TMI-11-171

Three Mile Island Nuclear Station, Unit 1  
Renewed Facility Operating License No. DPR-50  
NRC Docket No. 50-289

**Subject:** Three Mile Island Unit 1 Response to Request for Additional Information Related to the Proposed Administrative Changes to the Technical Specifications

**Response to Request for Additional Information Related to  
Proposed Administrative Changes to the Technical Specifications**

AmerGen  
Site Topography  
5 Miles Radius  
Township and Section Data

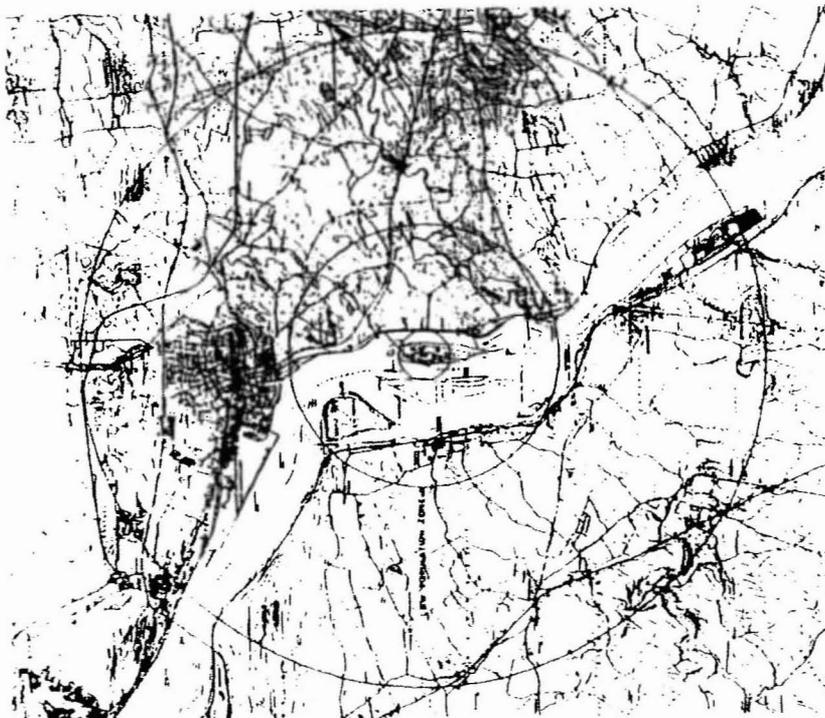
TS 5.1.1 describes Figure 5-2 as depicting the site topography for a radius of 5 miles from the station. The revised Figure 5-2 appears to have deleted the topographical lines. Therefore, please submit a revised Figure 5-2 that includes topographical information or justify, and submit, a revised TS 5.1.1.

TMI, Unit 1 withdraws the request to update TS Figure 5-2 for clarity. Attachment 2 contains a corrected proposed mark-up of Figure 5-2 which only revises the title box to reflect Exelon, the current licensee. Attachment 3 provides a revised "clean copy" of Figure 5-2.
